H11760

## DESCRIPTIVE REPORT

# Descriptive Report to Accompany Hydrographic Survey H11760

Project OPR-O168-FA

Figure 2: Junction between H11759 and H11760

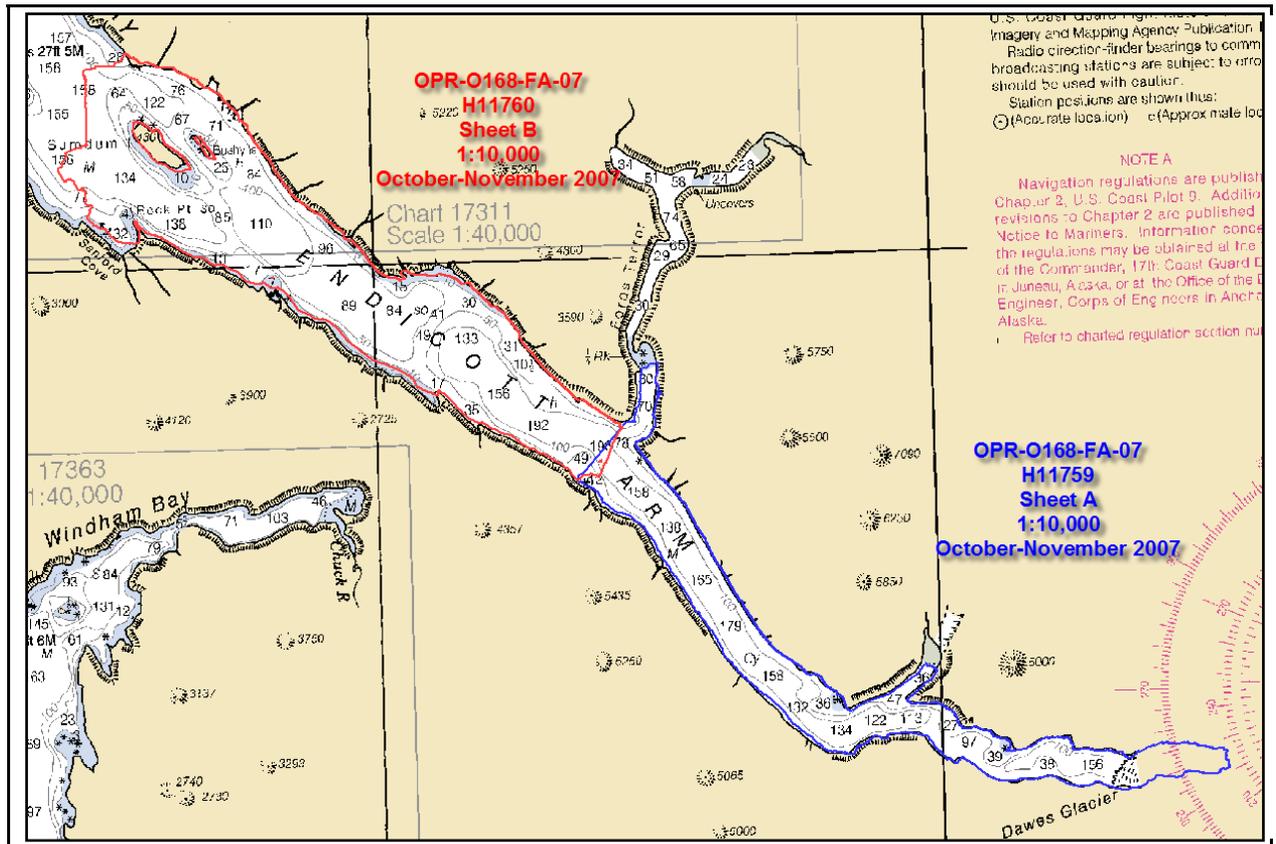
Survey H11760 junctions with H11759, which is Sheet A of the same project. The area of overlap between the sheets was reviewed in CARIS Subset Editor for consistency and data were found to be in good general agreement within one meter.<sup>2</sup> Overlap between survey sheets was approximately 100 x 400 meters.

<sup>2</sup> Concur.

Figure 4. Data reaccepted

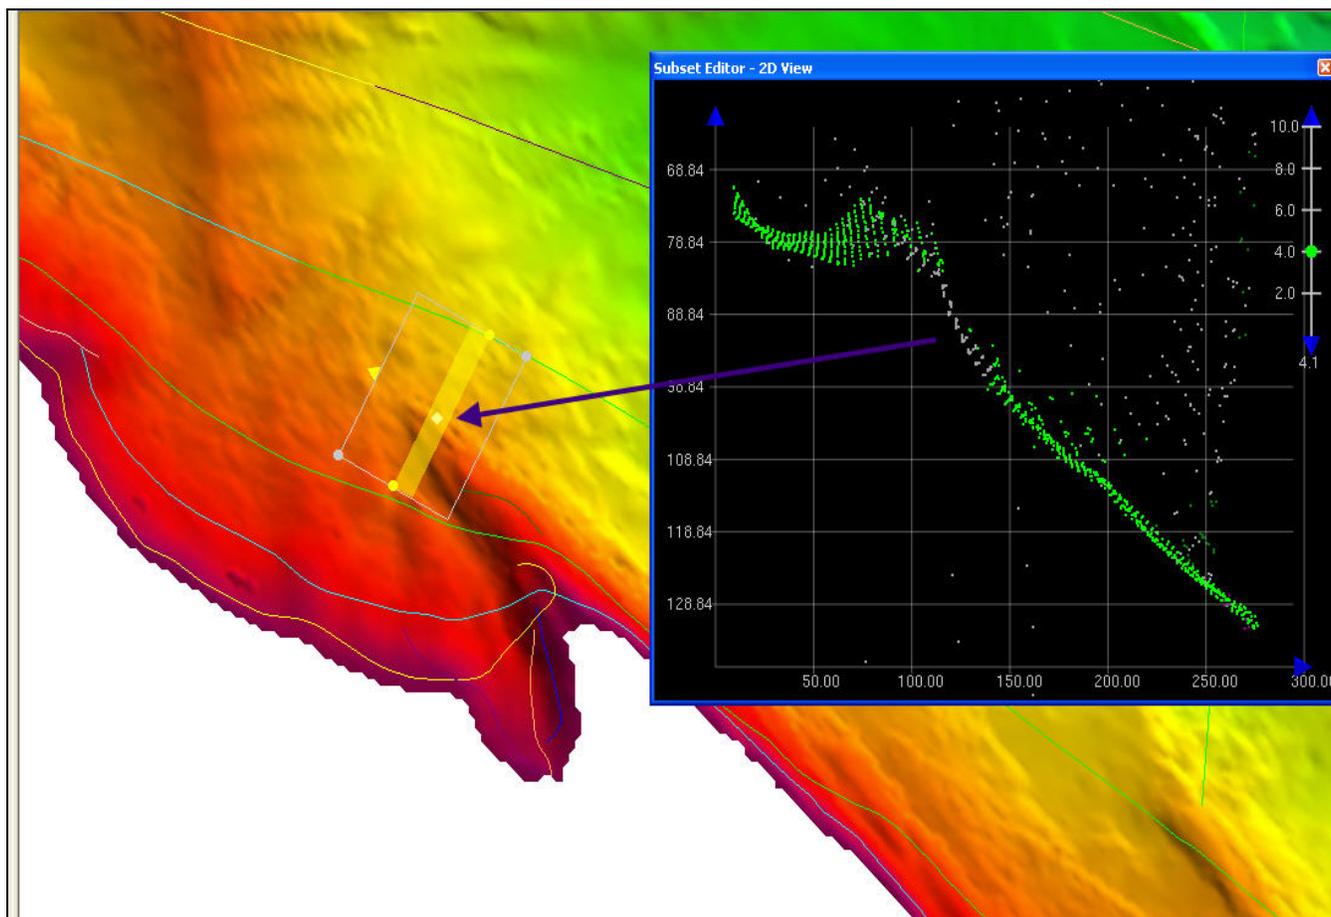
All data meet the data accuracy specifications as stated in the HSSDM, with the exception of several soundings on the south shore of H11760.<sup>6</sup> These soundings were initially rejected for high TPE values but were later reaccepted by the Hydrographer after review and assessment as suitable for inclusion in the survey. See figure 4.

<sup>6</sup> Concur.

*Figure 5. Charted 13 fathom sounding over steep ledge*

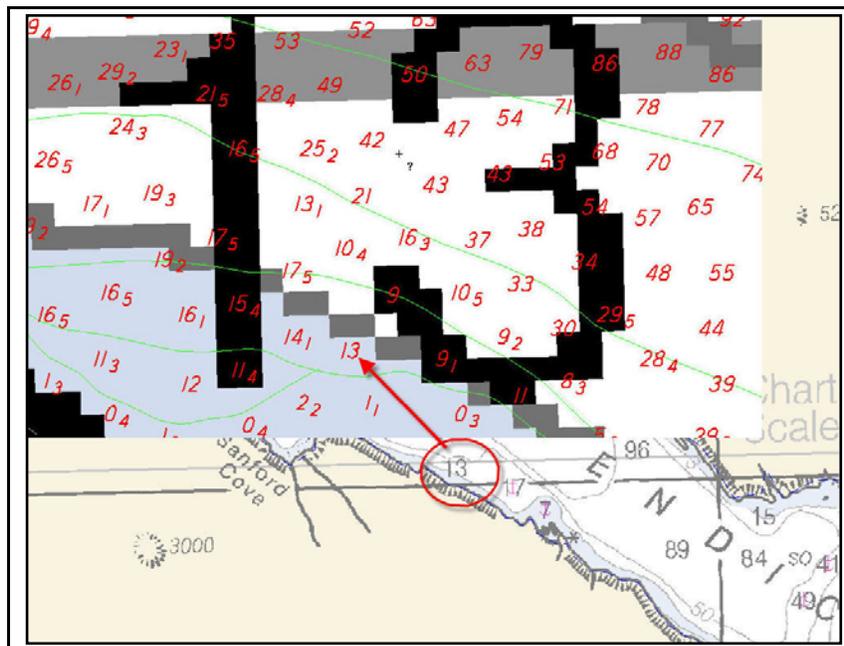
Depths from survey H11760 generally agreed within one to two fathoms with depths on chart 17360. Several shoaler depths on the chart slightly misrepresented the bottom on account of the “steep and deep” nature of the ledges on which they lie. Figure 5 depicts one such occurrence.<sup>11</sup>

<sup>11</sup> Concur.
